CABINET MEMBER FOR ENVIRONMENT – 25 FEBRUARY 2021

BICESTER – PROPOSED ACTIVE TRAVEL MEASURES

Report by Assistant Director Growth and Place, Communities

Project title
PROPOSED 20MPH SPEED LIMIT

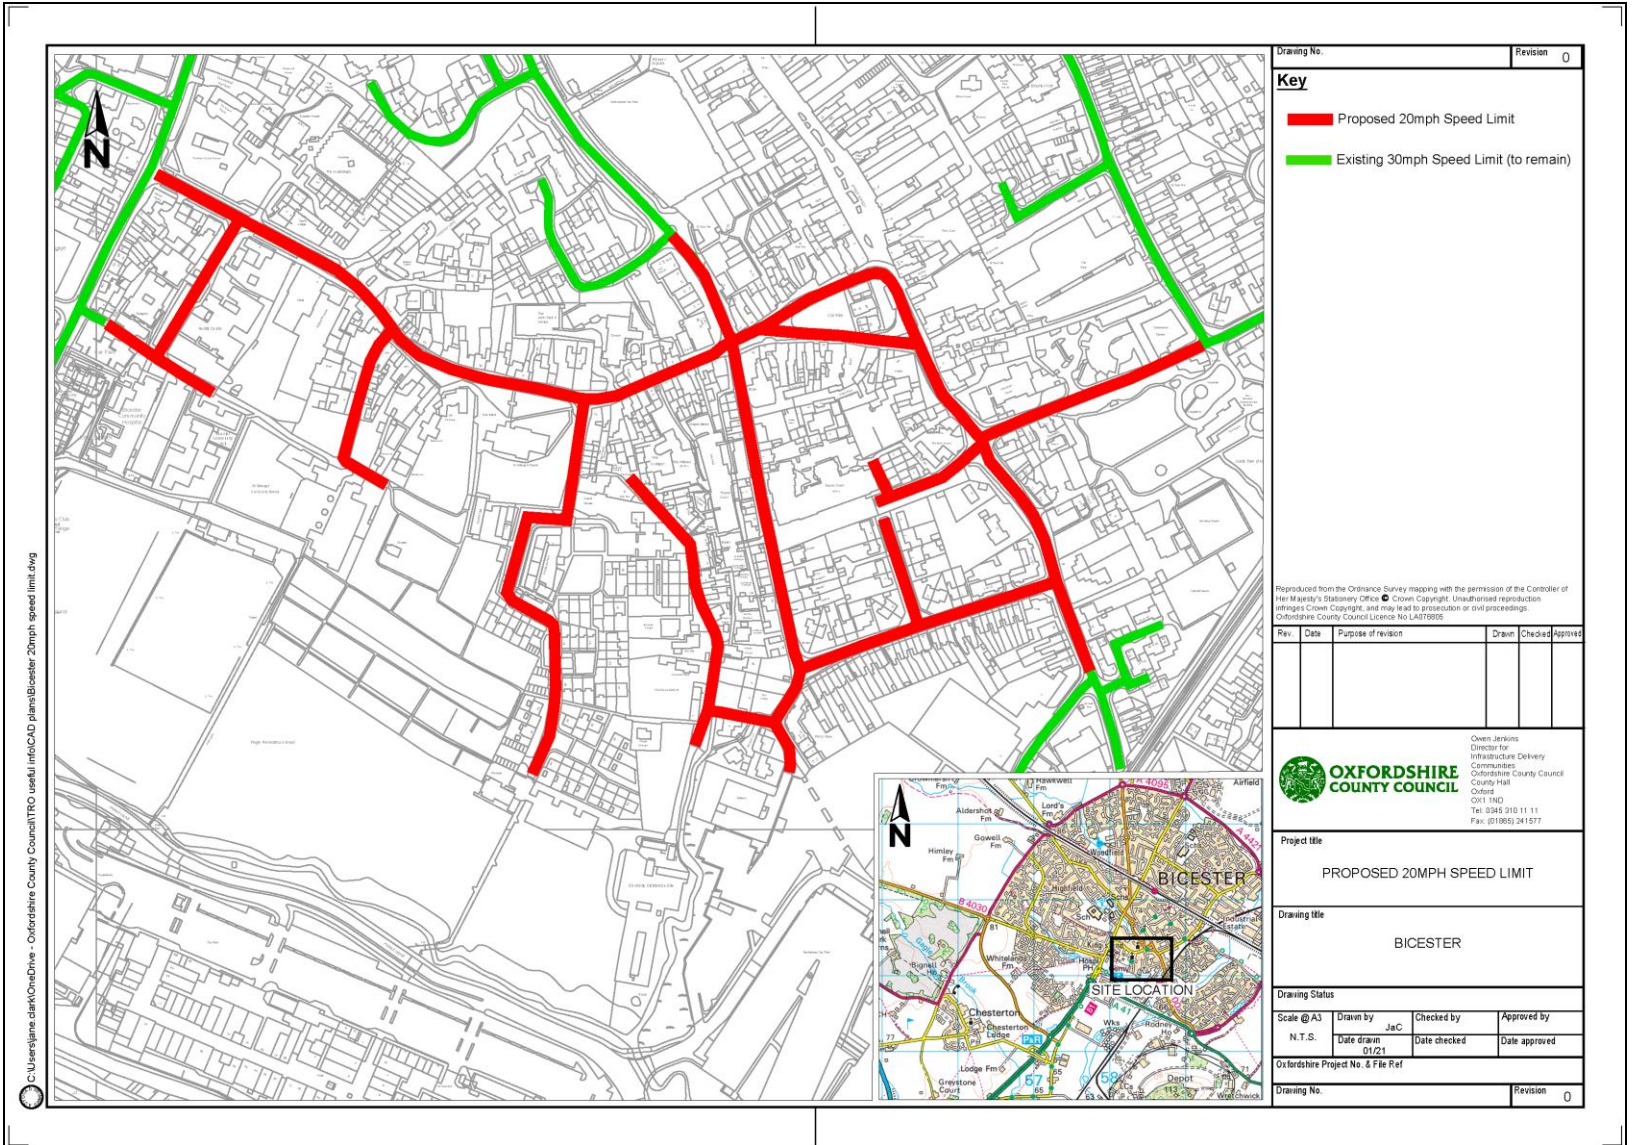
30. The 20mph speed limit order covers the areas where on-road cycling is proposed (and associated adjoining side roads). Two people objected to the 20mph proposal and seven voiced concerns. Research shows that lower speed limits, such as 20mph, are linked with increased walking and cycling as people feel safer. The speed data collected indicates that the 85th percentile speeds are lower than 24mph for all but two of the routes where 20mph is proposed and, therefore, no traffic calming measures are proposed. B4100 London Road at Priory Road and Site 7 - Launton Road recorded greater 85th percentile speeds at 28mph and 27mph respectively. We recommend that the 20mph speed limit is implemented in these areas and post scheme monitoring conducted to identify if speeds reduce due to the introduction of the 20mph scheme. A summary of the speed data from 2020 is available at Annex 6.

RESPONDENT	COMMENTS
<p>(1) Traffic Management Officer, (Thames Valley Police)</p>	<p>No objection – I know the areas well where a 20mph speed limit is being applied and have requested speed data which I have now scrutinised and considered in this response. The sites chosen included those contentious with the exception of Launton Road where speeds may be towards or above the limit which I cannot evidence. The application is a measured one which I welcome without any included or additional character or physical features.</p> <p>The current speed of traffic is a reliable indicator of how acceptable a new speed limit would be. The recognized way of ascertaining this level of self-compliance is the 85th percentile speed. If the 85th percentile speed is 7mph or more over the proposed limit it is unlikely to be effective without other measures such as engineering or continual enforcement. I have had site of recent speed data from Oxfordshire County Council taken on these roads as part of this proposal. I am also aware Highway Authorities prefer to use Mean speed rather than 85th percentile. I note that the mean speeds from the data provided are compliant to Police and DfT guidelines and not exceeding 24mph.</p> <p>Police are not opposed to lowering speed limits providing they are appropriate to the road environment and likely to have casualty reduction benefits. All aspects of the proposed speed limit are taken into account i.e. collision history, speed of existing traffic, road environment, enforcement, road character function with driver perception. It is essential that post implementation speeds are also monitored to evidence any speed reductions together with casualty reduction benefits in areas with actual or assumed hazard potential. This is specifically relevant where measures as here are to attract and promote walking and cycling.</p> <p>There is a proven link between road environment/character where in this application all sections are urban. Drivers must respect the need for a speed limit. If not accepted as realistic from our experience a limit will quickly be abused and be the source of constant demands for police action which would never significantly address the problem. Communities not privy to this response will thereafter be unhappy and dissatisfied and the value lost for this and other schemes.</p>

<p>(8) Local Resident, (Bicester)</p>	<p>20mph Speed Limit - Object Toucan Crossings - Support Shared-use Cycle Paths - Support Exp. Parking Restriction - Support Exp. Width Restriction - No opinion Exp. Loading Restrictions - No opinion Exp. Contraflow Cycleway - No opinion</p> <p>30mph feels safe enough, if reduced to 20 it would be too slow.</p>
